Title - Sujet East Pavil Rehab/Réhab de pavil est	
Solicitation No. - N° de l'invitation EP748-142417/A	Amendment No. - N° modif. 001
Client Reference No. - N° de référence du client 20142417	Date 2014-06-16
GETS Reference No. - N° de référence de SEAG PW-\$\$\$FG-340-65223	
File No. - N° de dossier fg340.EP748-142417	CCC No./N° CCC - FMS No./N° VME
Solicitation Closes - L'invitation prend fin at - à 02:00 PM on - le 2014-07-03	Time Zone Fuseau horaire Eastern Daylight Saving Time EDT
F.O.B. - F.A.B. Plant-Usine: <input type="checkbox"/> Destination: <input checked="" type="checkbox"/> Other-Autre: <input type="checkbox"/>	
Address Enquiries to: - Adresser toutes questions à: Brouillet, Richard	Buyer Id - Id de l'acheteur fg340
Telephone No. - N° de téléphone (819) 956-0457 ()	FAX No. - N° de FAX (819) 956-8335
Destination - of Goods, Services, and Construction: Destination - des biens, services et construction: DEPARTMENT OF PUBLIC WORKS AND GOVERNMENT SERVICES CANADA CENTRE BLOCK 111 WELLINGTON STREET OTTAWA, ON K1A 0A9

ADDENDUM NO.: 001

PROJECT NO.: R.027594.018

Centre Block East Pavilion Rehabilitation Project

1 TITLE BLOCK
ASK-001 1:1

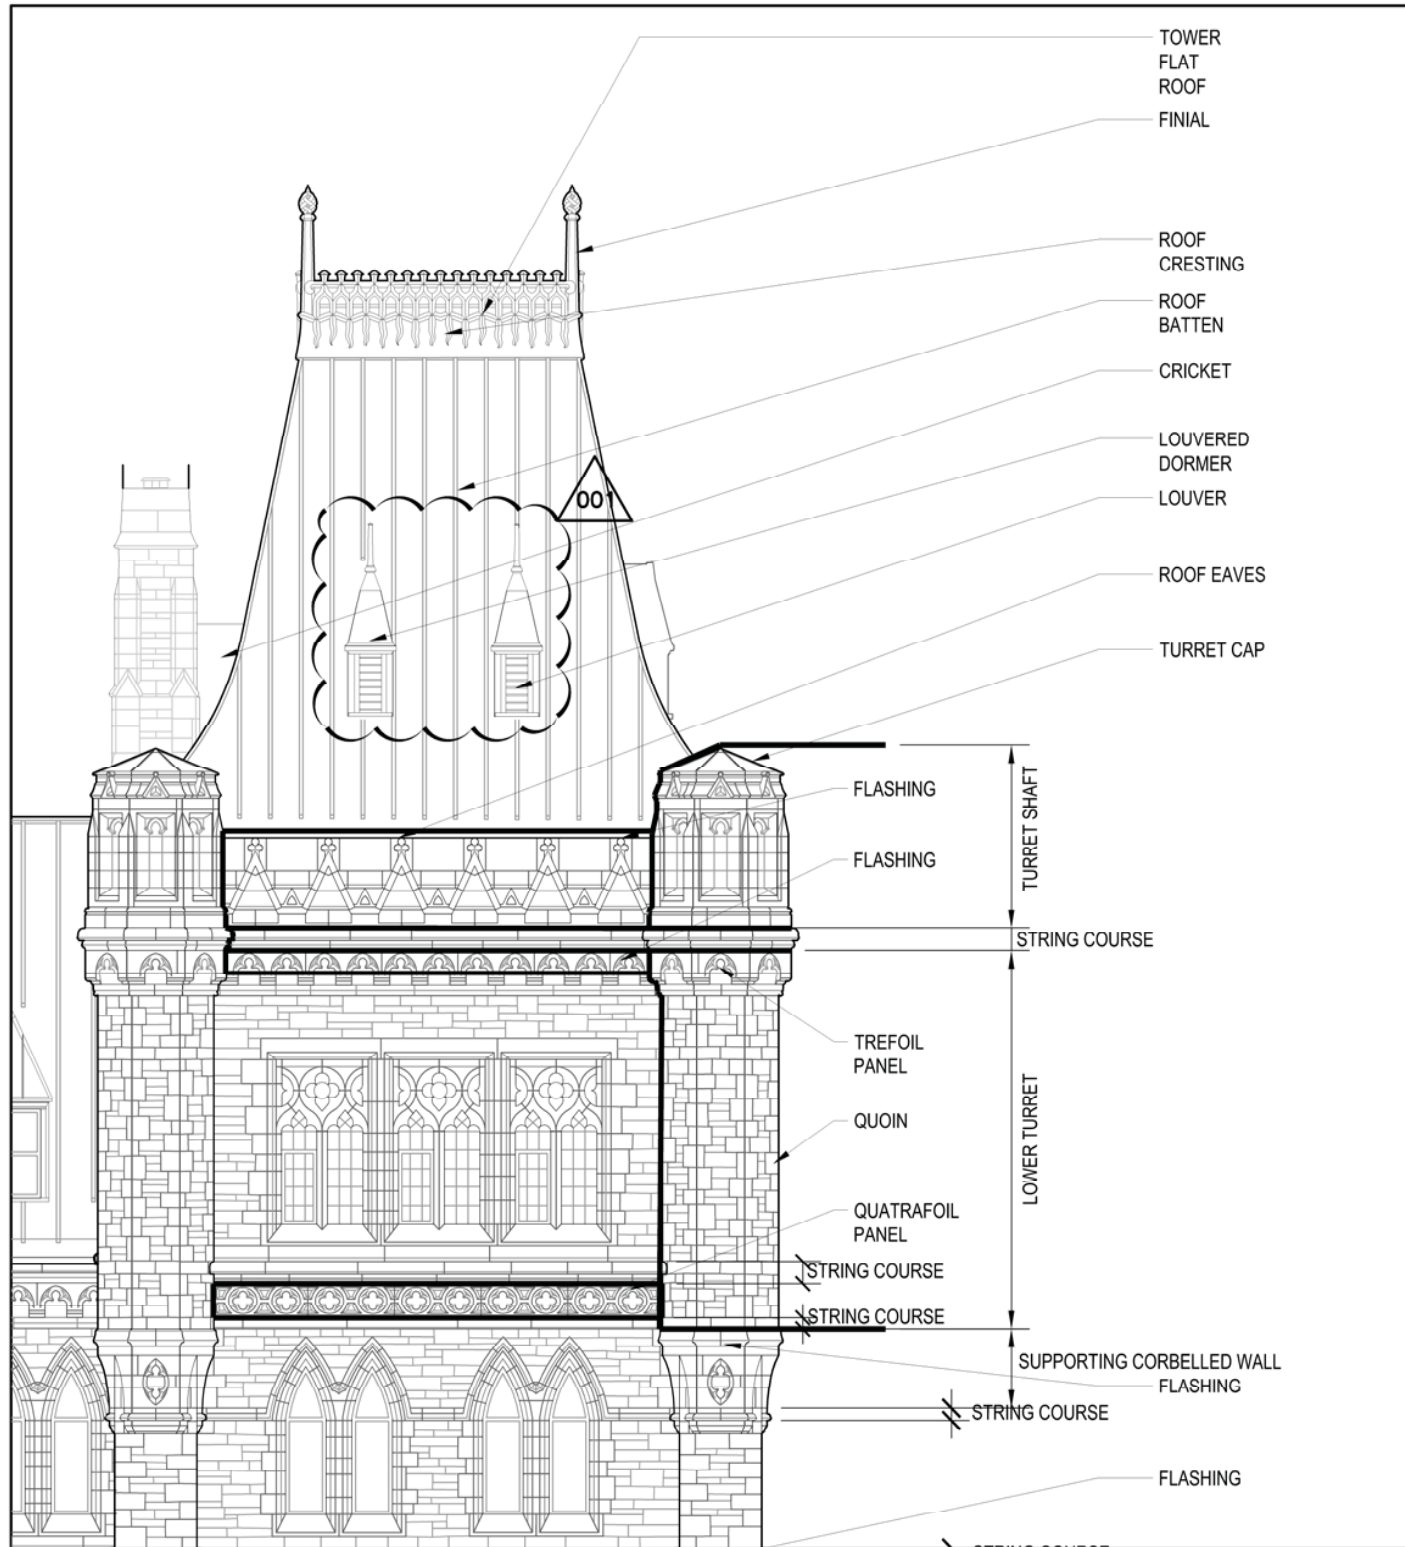
1. Drawings: **ALL** Title block. Refer to ASK-001 for modifications.
 1. **DELETE:** 1 Wellington
REPLACE WITH: 111 Wellington
2. Drawing: **A-001** Gen. Architectural – Index & Glossary.
 1. Refer to ASK-002 for modifications.
3. Drawing: **A-304** Window Interventions – Types FF, J, R & Details
 1. Refer to ASK-003 for modifications.
